Model: Internal Finisher Type 3352	Date: 12-Sep-11	No.: RD586001a
------------------------------------	-----------------	----------------

Subject: Firmware Release Note: Internal Finisher Type 3352		Prepared by: T. Nihei	
From: 2nd Tech Service Sect., MFP/Printer Tech Service Dept.			
Classification:	<input type="checkbox"/> Troubleshooting <input type="checkbox"/> Mechanical <input type="checkbox"/> Paper path <input type="checkbox"/> Product Safety	<input type="checkbox"/> Part information <input type="checkbox"/> Electrical <input type="checkbox"/> Transmit/receive <input checked="" type="checkbox"/> Other (Firmware)	<input type="checkbox"/> Action required <input type="checkbox"/> Service manual revision <input type="checkbox"/> Retrofit information <input checked="" type="checkbox"/> Tier 2

Model: Internal Finisher Type 3352		Date: 26-Dec-11	No.: RD586002
Subject: Stopper		Prepared by: T. Nihei	
From: 2nd Tech Service Sect., MFP/P Tech Service Dept.			
Classification:	<input checked="" type="checkbox"/> Troubleshooting	<input type="checkbox"/> Part information	<input type="checkbox"/> Action required
	<input type="checkbox"/> Mechanical	<input type="checkbox"/> Electrical	<i

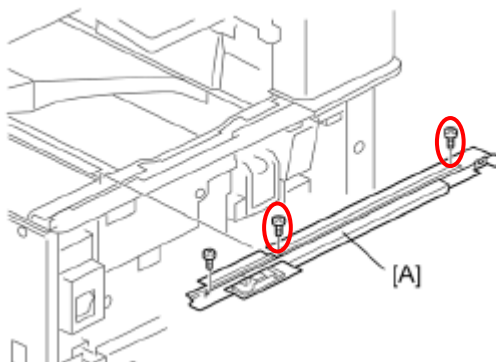
In some cases, the internal finisher slides outward and becomes disconnected from the mainframe when the following operations are performed:

- The duplex cover is closed with force
- The extension tray is extended during a copy job (which can cause a paper jam)

The two operations described above produce slide loads that are larger than expected, causing the finisher to slide to the left.

A stopper was added to the front rail (see **Cut-in Serial Numbers** below).

If the symptom occurs, attach the new stopper (P/N D5869900) to the front rail.

Procedure

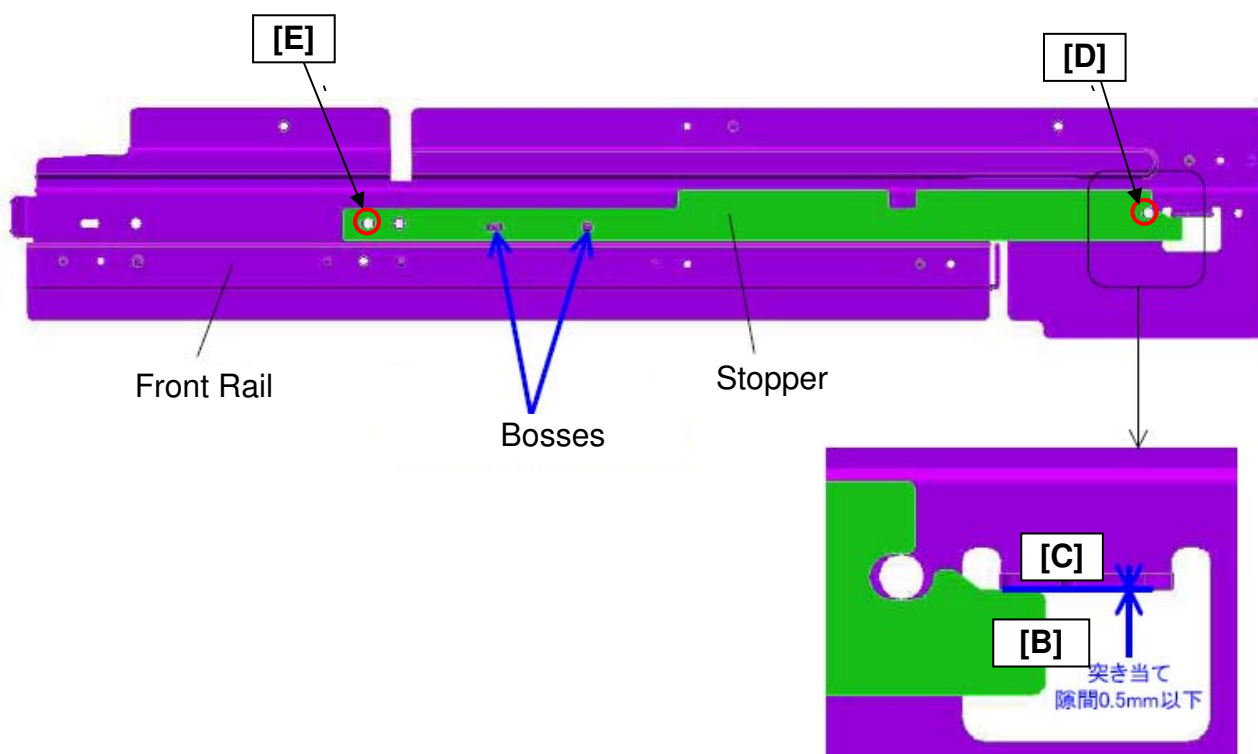
1. Remove the internal finisher and the finisher right cover (or Punch Unit if installed).
2. Remove the screws (screw x 2).

3. Clean the front rail with alcohol and a cloth.
4. Remove the double-sided tape from the stopper (D5869900).
5. Line up the two bosses on the front rail with the two holes in the stopper, and then push the bosses through the holes.
6. Make sure the gap between the right edge of the stopper [B] and rail [C] is 0.5mm or less.
7. Using the two screws you removed in Step 2, fasten the stopper in place at screw hole [D], and then at screw hole [E].
8. Reattach the internal finisher and finisher right cover (or Punch Unit if installed).
